**Sign Variance Report  
120 Church Street**

| <b>Reference Number:</b> | 06-160318  |

To review and make recommendations on a request by Prudence Wong of Forward Signs Inc. on behalf of 15918863 Ontario Limited for approval of variances from Chapter 297, Signs of the former City of Toronto Municipal Code to maintain, for identification purposes, a non-illuminated fascia sign at the second and third floor levels, on the front elevation of the building at 120 Church Street.

### Previous Elevation

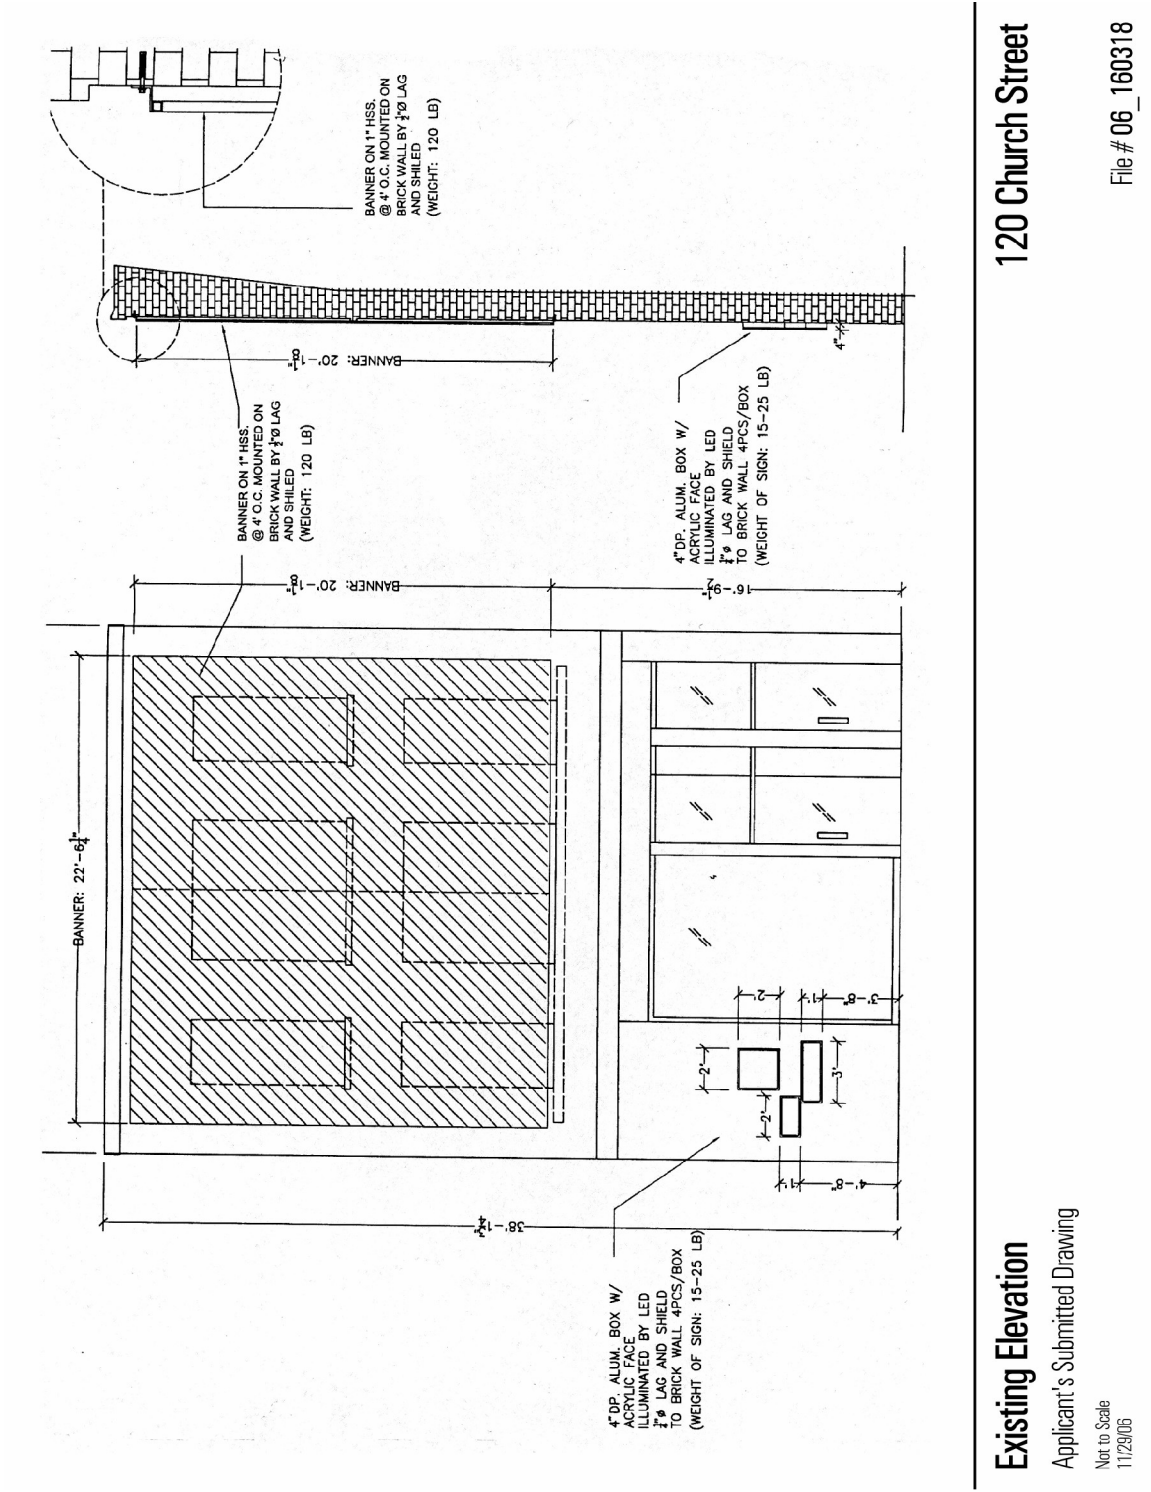
The sign is too large, too high and covers the second and third floor building elevation, including the windows.

**Existing Elevation**  
 Applicant's Submitted Drawing

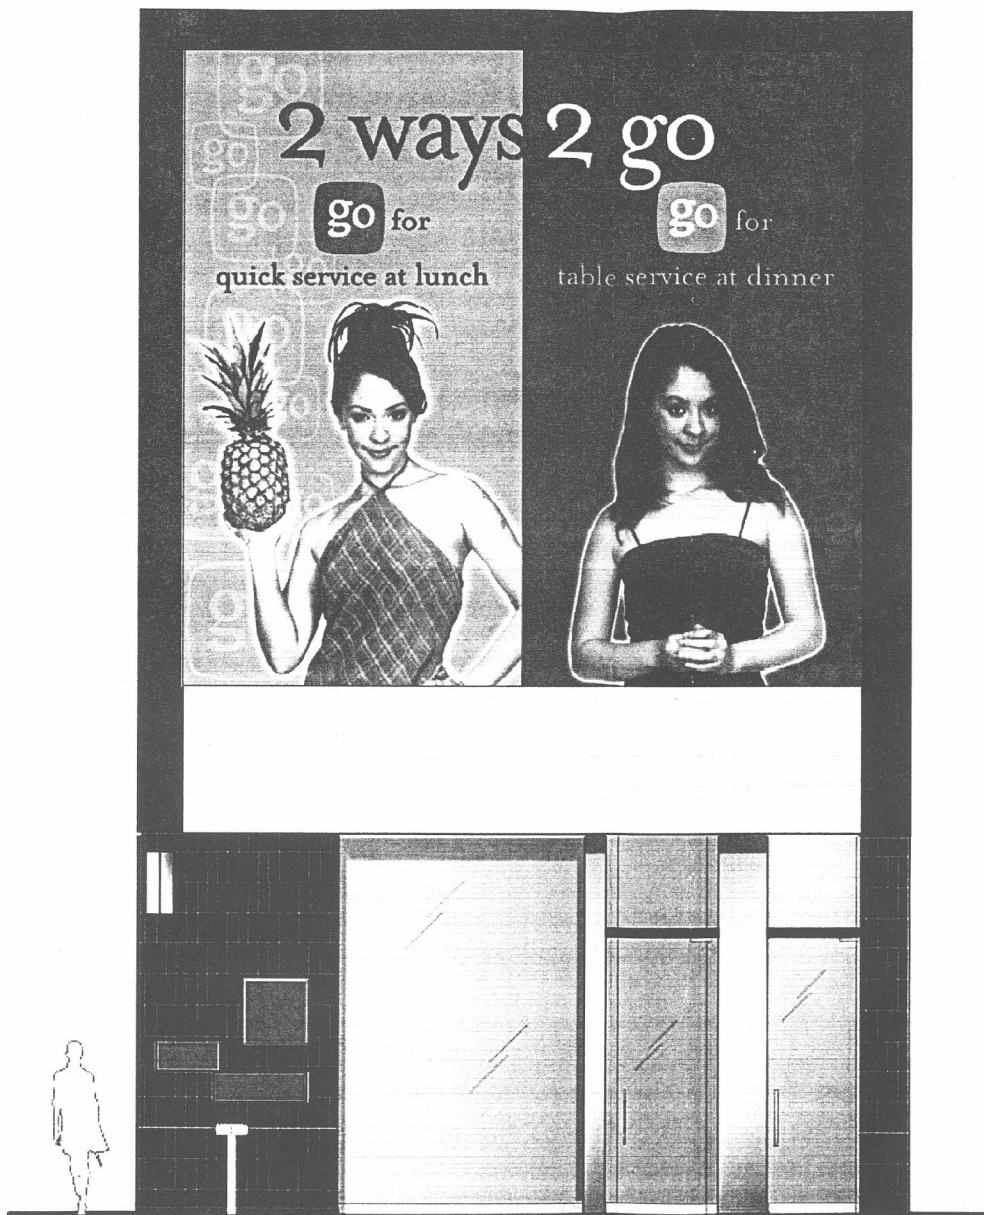
| Sign By-law Section and Requirements | Applicant’s Proposal   | Required Variance   |
|--------------------------------------|--|---|
| (1) Chapter 297-10 D(5)(d)           | The sign is 6.86m wide and 6.13m high with an area of 42.05m <sup>2</sup> .  | The 42.05m <sup>2</sup> fascia sign would exceed by 38.15m <sup>2</sup> , based on 15% the maximum 3.90m <sup>2</sup> of the building face of the second floor commercial unit. |
| (2) Chapter 297-10 D(5)(d)           | The sign is located 11.6m above grade and it would cover almost all second and third floor frontage of the building. | The 11.6m sign height above grade would exceed by 1.60m, the maximum 10.0m height above grade that is permitted.  |
| (3) Chapter 297-10 D(5)(g)           | The sign has an area of 42.05m <sup>2</sup> .  | The 42.05m <sup>2</sup> fascia sign would exceed by 17.05m <sup>2</sup> , the maximum 25.0m <sup>2</sup> sign permitted.  |
| (4) Chapter 297-10 E(6)              | The sign covers or obstructs all second and third floor windows on the front elevation of the building.              | The Municipal Code does not permit any sign to obstruct or interferes with a window of the building.  |

With respect to the fourth variance, the pattern of windows is part of basic architectural integrity of a building and involves a two-way relationship - being able to see inside as well as to see out. Staff sees no rationale for approving variances that would set a pattern of allowing windows to be covered up, contrary to the original intent of the Municipal Code.

1. City Council refuse the request for variances to maintain, for identification purposes, a non-illuminated fascia sign at the second and third floor levels, on the front elevation of the building at 120 Church Street.
